AGENDA FOR REGULAR MEETING VILLAGE OF TINLEY PARK PLAN COMMISSION

**June 7, 2018 – 7:00 P.M.
Council Chambers
Village Hall – 16250 S. Oak Park Avenue**

**Item #2 PUBLIC HEARING: VERIZON WIRELESS – 8201 W. 163RD STREET
SITE PLAN APPROVAL AND SPECIAL USE PERMIT WITH VARIATIONS**

PLAN COMMISSION STAFF REPORT

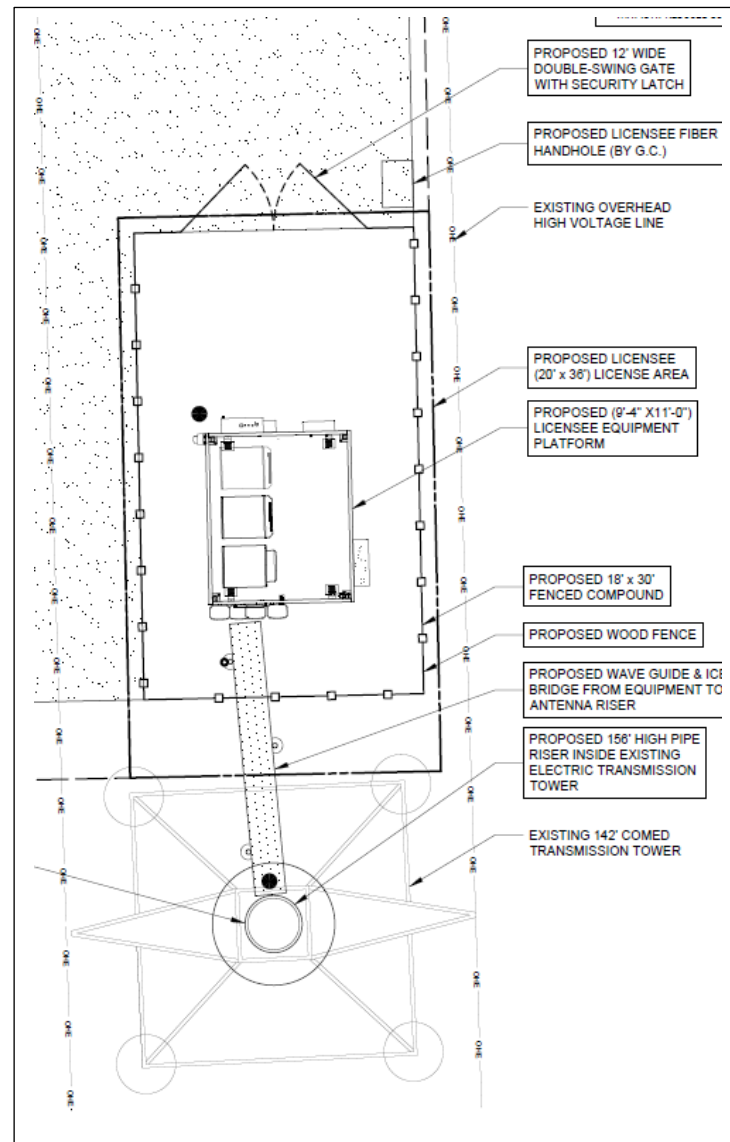
Section III W.5.C. requires ground level buildings and structures be constructed with masonry facades. The applicant is proposing to screen the steel platform equipment with six (6) foot wood privacy fence.

Open Item #5: A Variation to not require the Steel Platform to be enclosed within a masonry façade building. Petitioner has agreed to enclose the equipment within a masonry building.

5. *A Variation to not require the Steel Platform to be enclosed within a masonry façade building. This variation is no longer needed. The Petitioner has provided renderings of a pre-fabricated facebrick equipment shelter. Staff recommends that the brick color match the fencing that will be around it. In addition they will need to provide cut sheets of the proposed mounted light fixtures.*

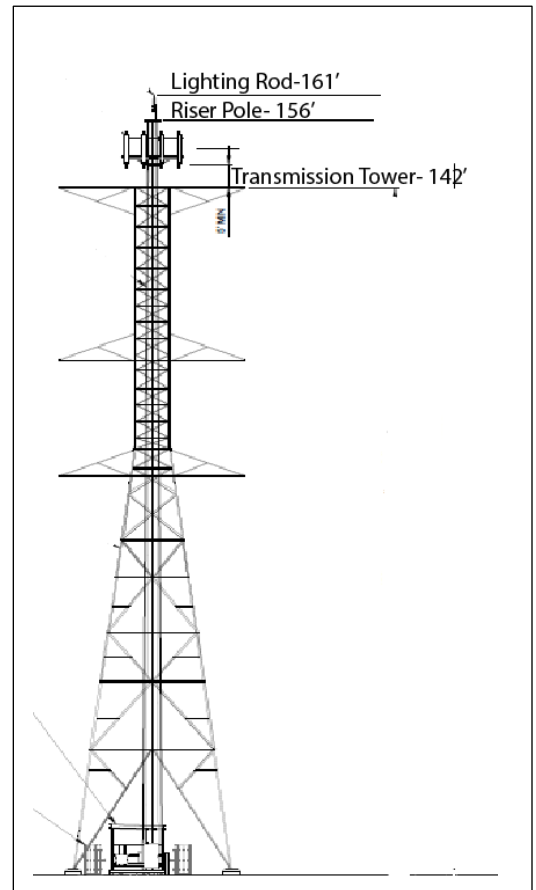
Open Item #6: Staff recommends the access drive be asphalt. Petitioner has revised the plans to include asphalt for the proposed access drive. Plans will be revised to indicate all areas within the fence to be paved.

Open Item #7: Staff recommends an additional gate be installed to discourage the public from accessing the drive from the bike path. After further discussion, this recommendation is no longer needed.

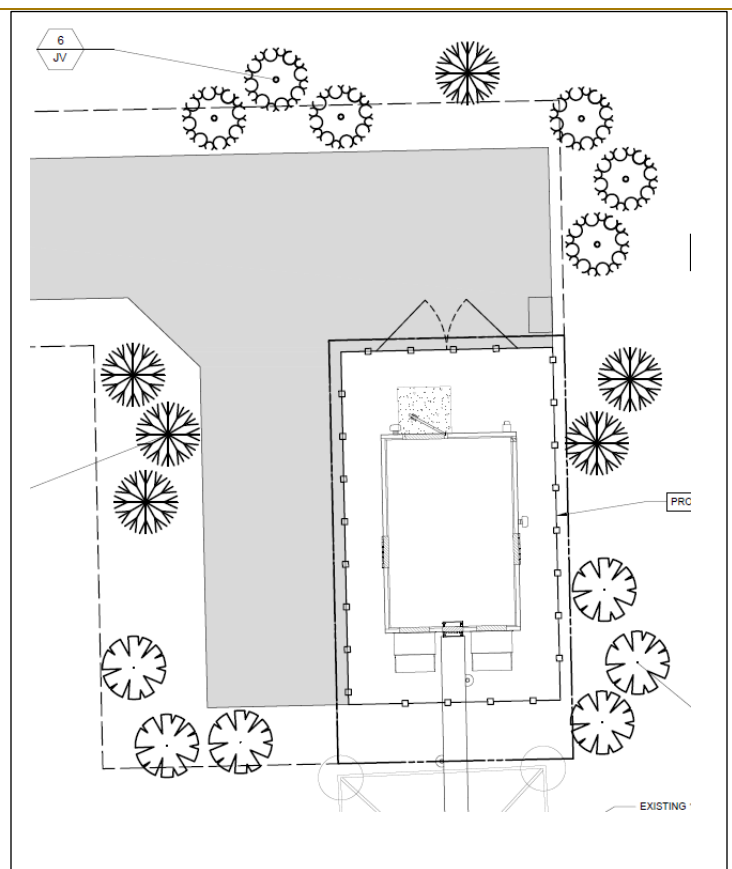
The Petitioner is proposing a combination of six (6) Hawthorne Trees; six (6) Eastern Red Cedar and six (6) Eastern White Pine trees. They will be installed in groupings of three around the leased area and will be eight (8) feet in height when installed. The plan indicates a wood fence. It should be revised to incorporate a Vinyl fence.

Open Item #8: Applicant needs to provide staff with a landscape plan that meets the intent of the code. The plan should also incorporate comments provided by the

Village's consulting landscape architect. Petitioner has submitted a landscape plan.

SHEET TITLE
EQUIPMENT
ENCLOSURE
ELEVATIONS

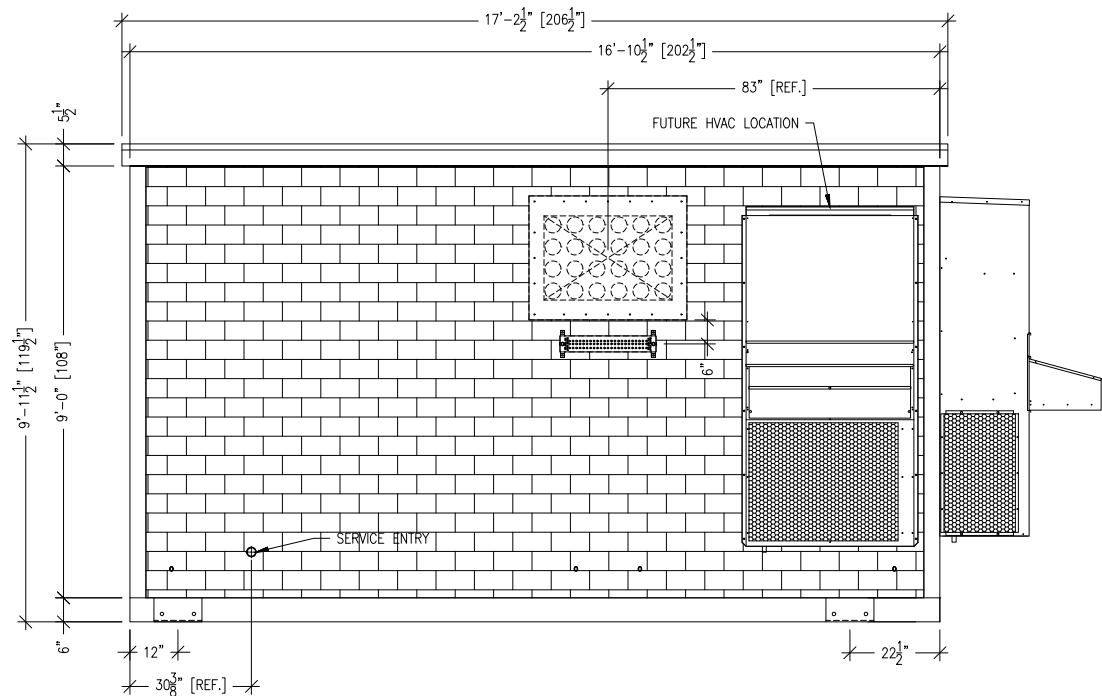
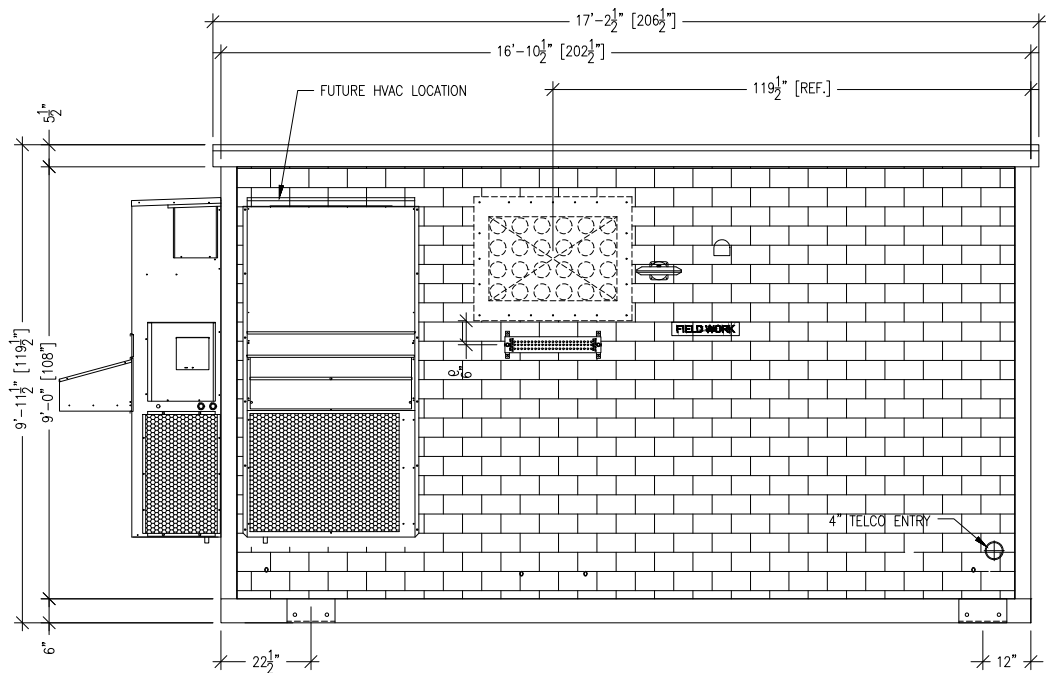
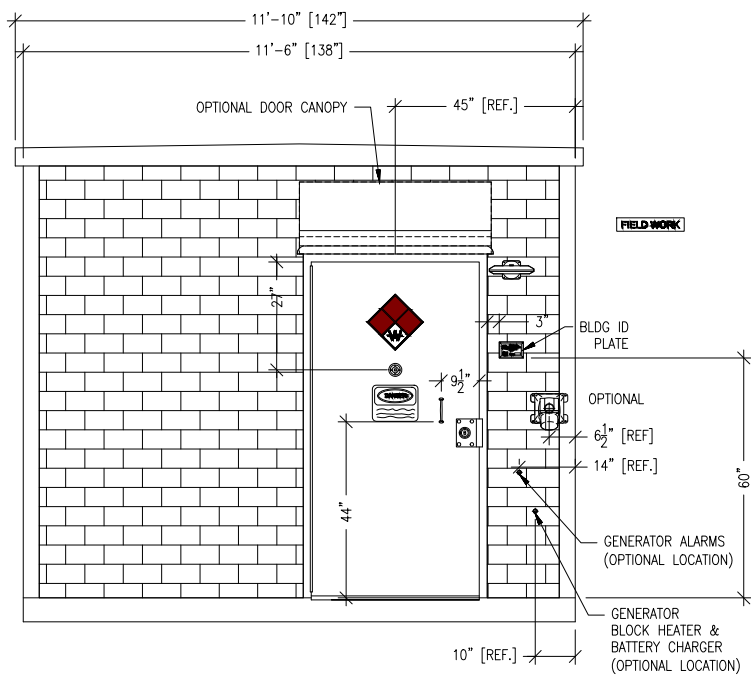
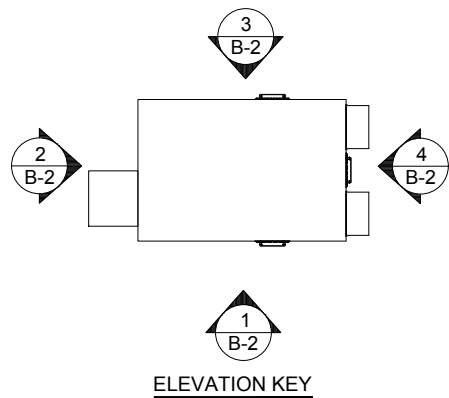
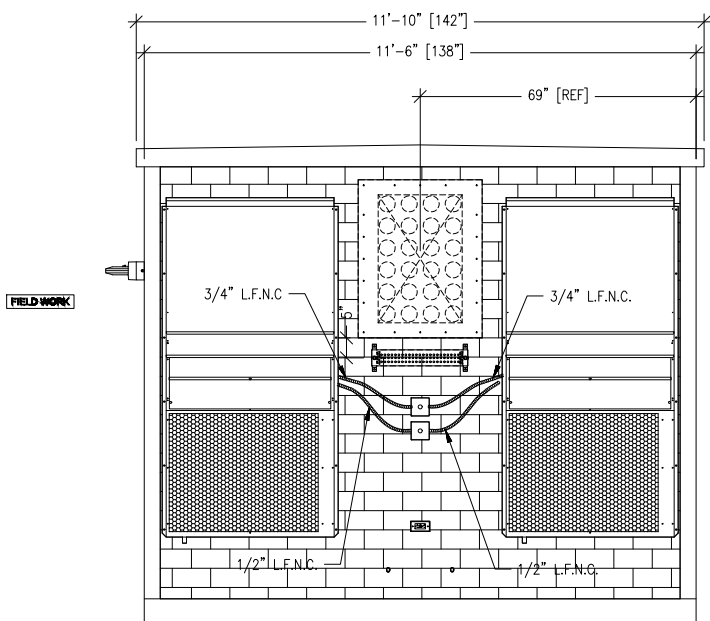
The Petitioner has submitted revised plans which proposes a pre manufactured equipment shelter with facebrick that is 16'-10 1/2" X 11'-6" X 10' with two (2) exterior AC units attached to the outside of it. There building can have an additional AC unit added for the future. The images below are examples of facebrick that can be used on equipment shelters. Staff prefers the lighter facebrick color to match the taupe vinyl fencing that will be around the structure. There are two exterior lights proposed on the building. One is identified as an exterior light with photocell and the other is an emergency light. The previous proposal did not provide for exterior lighting fixtures. Staff does not see the need for lighting now that the equipment is in a shelter. If light fixtures are to remain, cut sheets will need to be provided for staff to review. All lights should be downward facing and shielded.

1. The proposed 6 foot fence by made of vinyl instead of wood and be a taupe color
2. The facebrick of the structure match the taupe fence around it
3. Outstanding Public Works and Engineering items must be addressed prior to issuance of a building permit; *and*
4. *[...any other conditions as suggested by the Plan Commission.]*

Nonconforming parking in IDOT R.O.W.

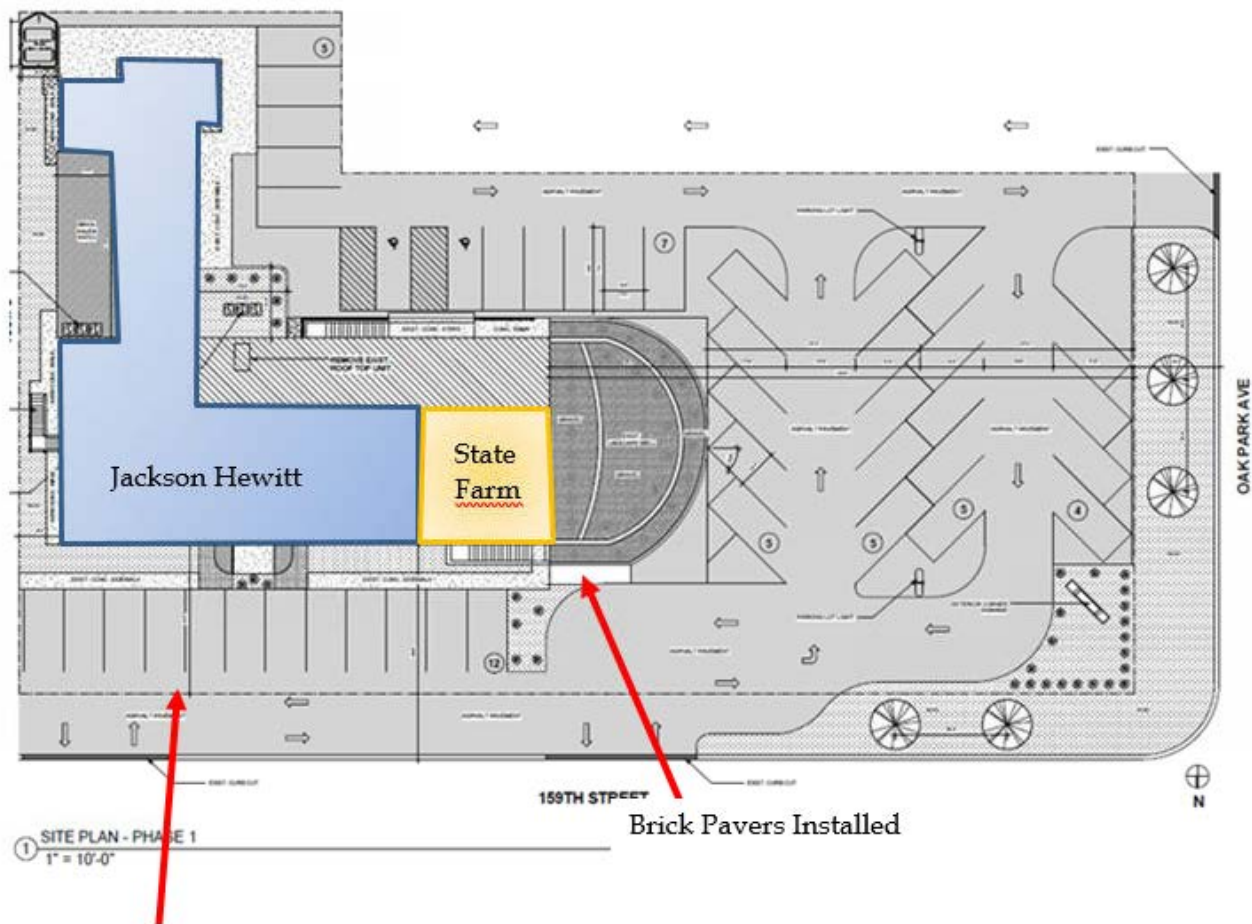
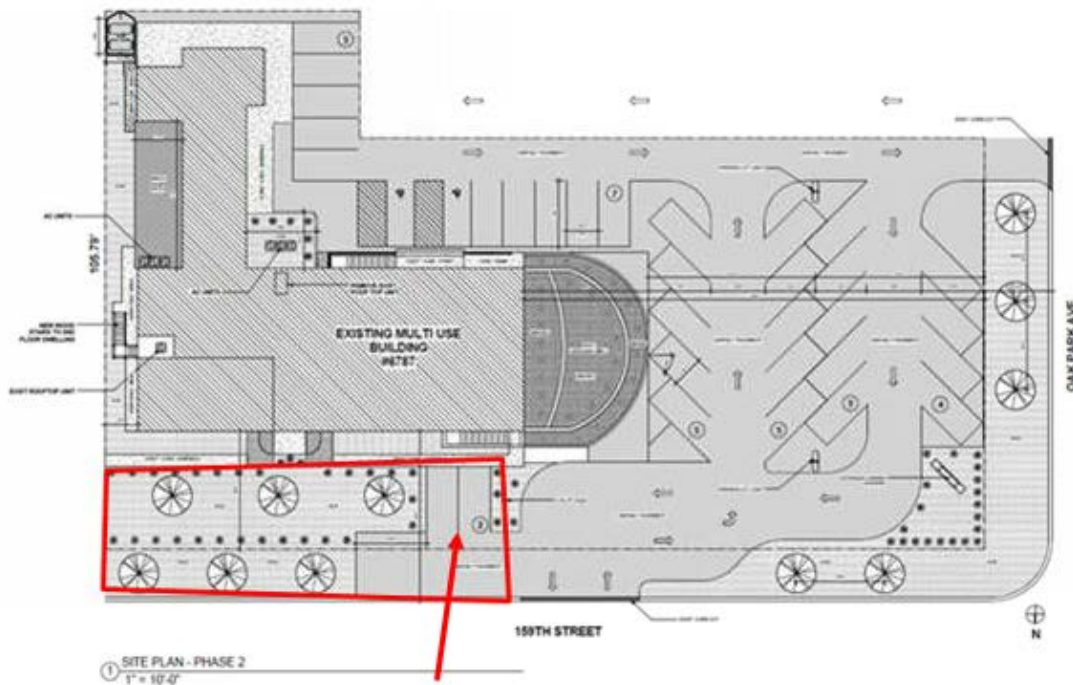
The Phase 1 improvements (shown below) propose maintaining the nonconforming parking stalls and drive aisle in front of the building along 159th Street. The remaining portion of the parking lot would be restriped. Landscaping will be installed around the proposed monument sign and the Oak Park Avenue parkway trees and foundation plantings are to be installed.

The Phase 2 improvements (shown below) plan to remove the parking and drive aisle along 159th street and replace with sod and plantings. The owner proposes maintaining two (2) parking stalls on the north side of the building for the apartment use. This phase is subject to IDOT approval. Staff has advised the applicant that they do not believe IDOT will allow the property to continue to use their R.O.W. It should be noted the curb cut on 159th Street will be restricted to 30 feet in width. The plans shows a curb cut of 33 feet.
